TOWN OF ARLINGTON
MASSACHUSETTS 02476-4908

March 16, 2021

**Re: Notice of Proposed Revisions to "Thorndike Place," Arlington, MA
(MassHousing ID #778/ #779)**

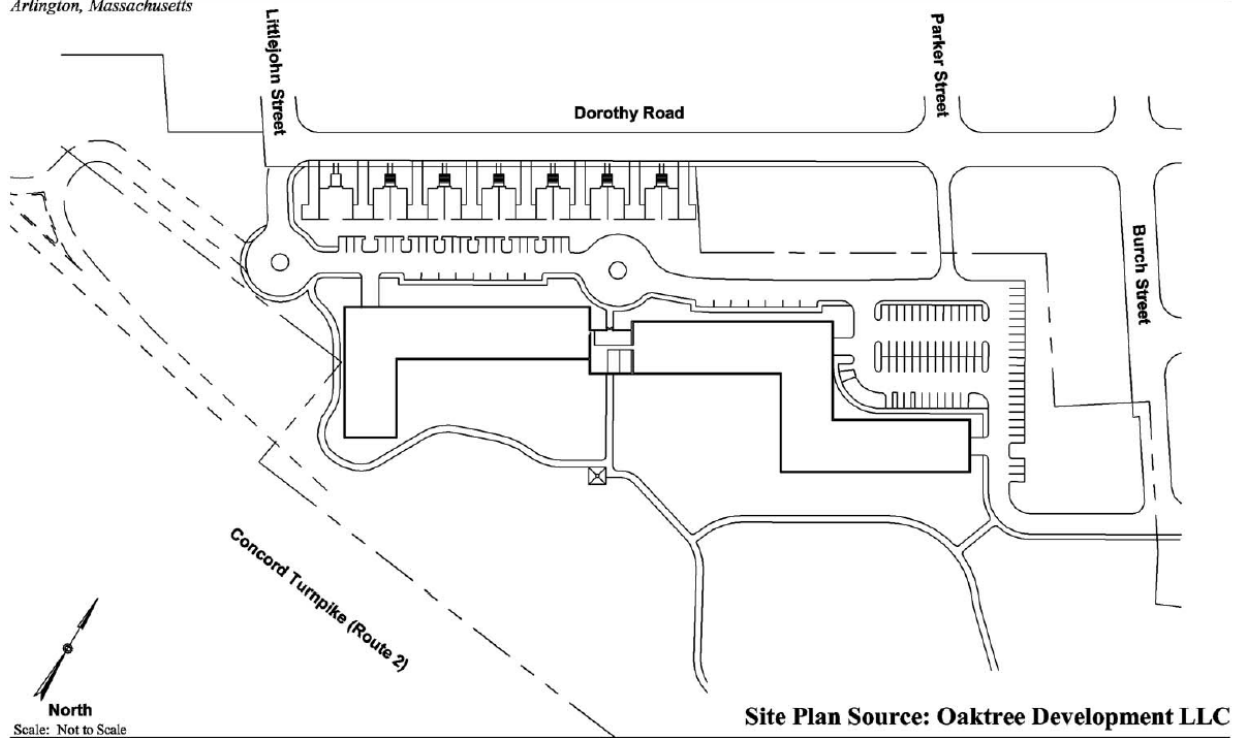
In addition to the foregoing, the project granted preliminary site approval by the revised proposal before you makes no mention of two critical elements to your traffic and transportation assessment and overall evaluation of site appropriateness. First, the site has no access whatsoever to or from Route 2 and no longer features direct access to Parker Street or Burch Street. In its revised form all vehicular access is provided by Little John Street and Dorothy Road, which are essentially the same street for the purposes of this project. Second, the revised project has no walking path improvements to connect the site to a more direct access points to the Alewife T Station or the Minuteman Bikepath. These elements were featured pieces in establishing the appropriateness of a site that still proposes to add parking nearly 200 cars to frequent narrow residential streets. Their abandonment constitutes further substantial and detrimental changes. Four vehicular access points and at least one supplementary pedestrian access point have been reduced to place all vehicular and pedestrian access to a single roadway.

A. Reduced Traffic Access Points & No Access from Route 2

One of MassHousing's principal findings with respect to the general appropriateness of the site for redevelopment was that "[t]he Site is accessible to Route 2, which borders the site." See Eligibility Letter at Attachment "1;" Findings "(b), p. 8. Indeed, both the site plans submitted by the Applicant to MassHousing, and the April 2014 Traffic Impact and Access Study by MDM Transportation Consultants highlighted access to Route 2 a feature for MassHousing given the constraints of the modest neighborhood streets otherwise necessary for ingress and egress. As MDM's report stated:

(As can be seen in MDM's "Figure 2," both the Rt. 2 Ramp and Burch Street and Parker Street access were prominent features of the Site Plans submitted for Site Approval to MassHousing)

Neither the current revised project plan nor any plan submitted to the Arlington Zoning Board of Appeals within the Applicant's Comprehensive Permit have maintained or even proposed an off-ramp or any other direct access to Route 2. Indeed no alternatives whatsoever have been provided to achieve "reduc[ed] dependence of local roadways" by the Applicant in the Revised Project before you, with or without any of the other changes referenced by the Applicant in their recent Notice.
